Proposed Plan Change 13 – Waipa District Council

Statement of Further Submission

25m Collector Road / Green Spine Road

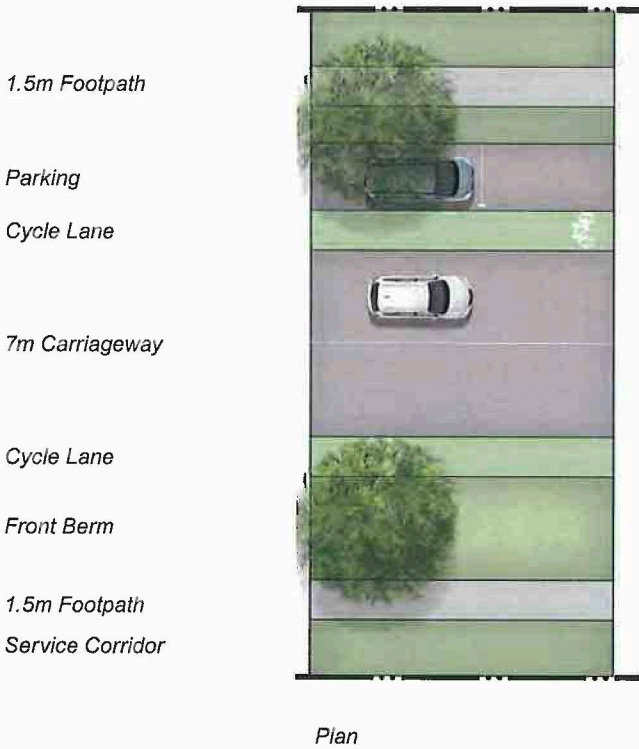
- Firstly the standards proposed for the main collector road being 25m wide and containing a dual carriageway and a 1.5m footpath, parking lane and a cycle lane on each side of the road is excessive for a low density large lot residential zone.
- Secondly the alignment of the collector road is not possible to construct economically due to geographic constraints. The staff response to our submission is that it should be rejected due to a lack of technical engineering advice. This is not appropriate as the technical advice relied upon by Council is obviously erroneous and should be amended by Council.

We cannot identify anywhere else within the District where a 25m wide collector road is being required in a low density large lot residential area and even T 11, which is a standard residential development and part of this Plan Change, only requires the standard 20m road width.

RELIEF SOUGHT: We request that the formation standards of the collector road be the same as other similar developments within the District in similar circumstances and that it be clearly defined that the alignment of the collector road is indicative only.

4.3 Building Setbacks (Large -Lot Residential (2,500m² to 5000m²))

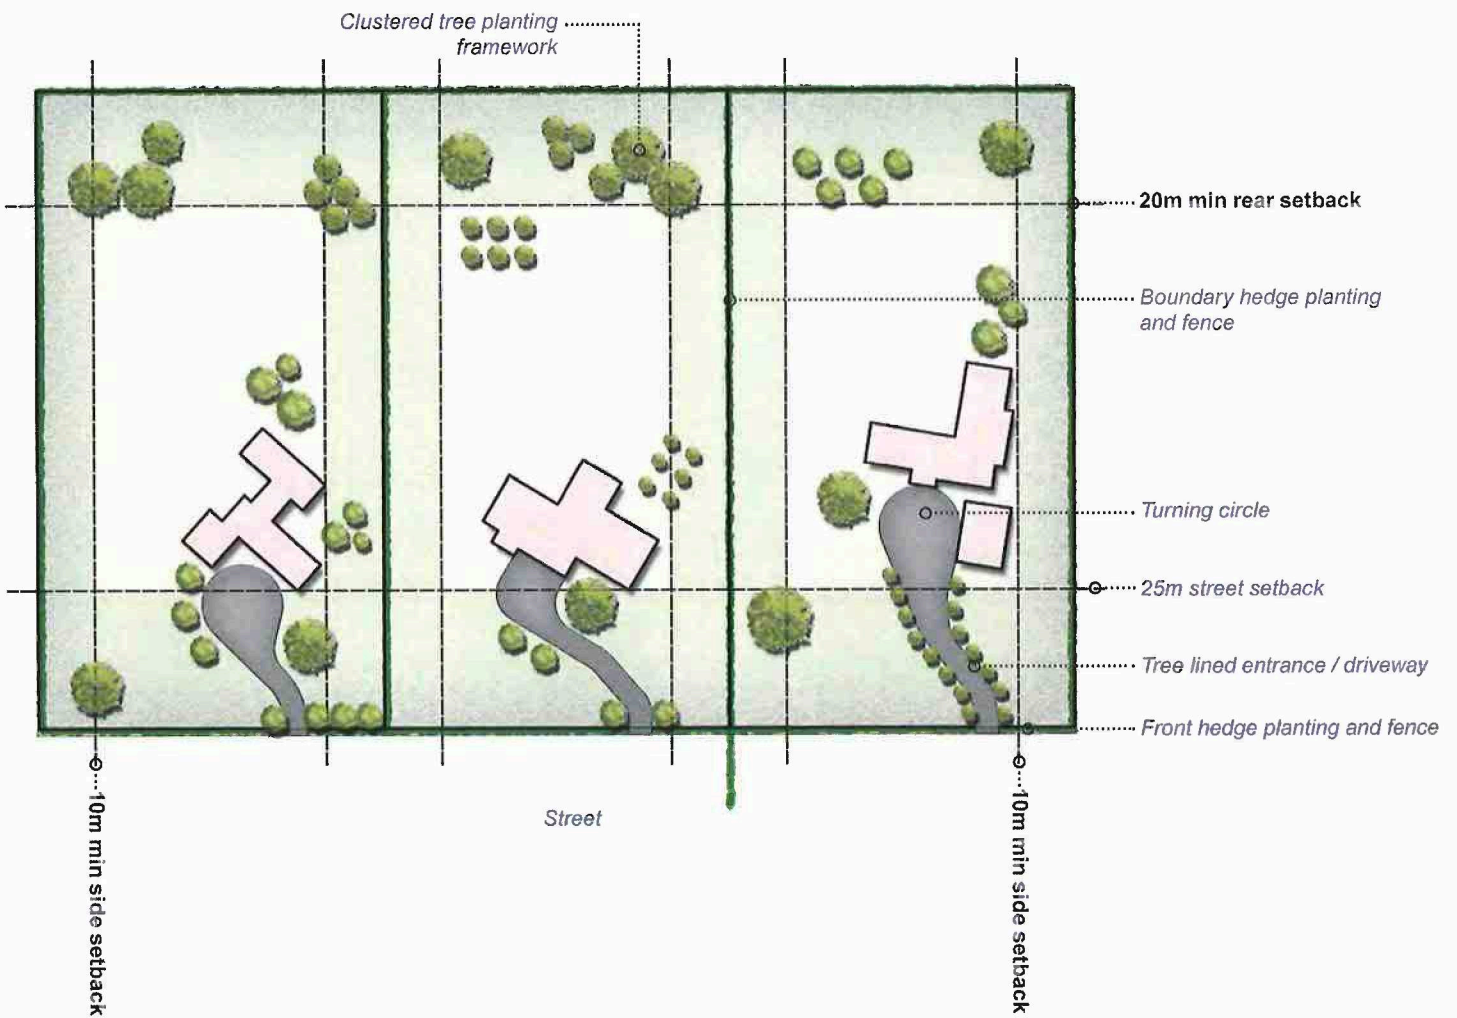
- The yard requirements of a 25m front yard, a 20m rear yard and two side yards of 10m each are impractical on a 2500 square metre section. The indicative plan on page 13 of their design guidelines shows three potential section developments using these bulk and location requirements but the sections shown would be at least 5000 square meters. A simple 2500 square metre section would 50m by 50m. Taking the proposed bulk and location requirements into account you have a 5m wide strip in the middle of the section to build a house. If these standards are imposed it will be necessary to increase the size of the sections thus wasting even more productive land.

RELIEF SOUGHT: We request that the existing District Plan standards for residential developments apply to the T6 Large Lot Residential Zone and not those proposed in the design guidelines.
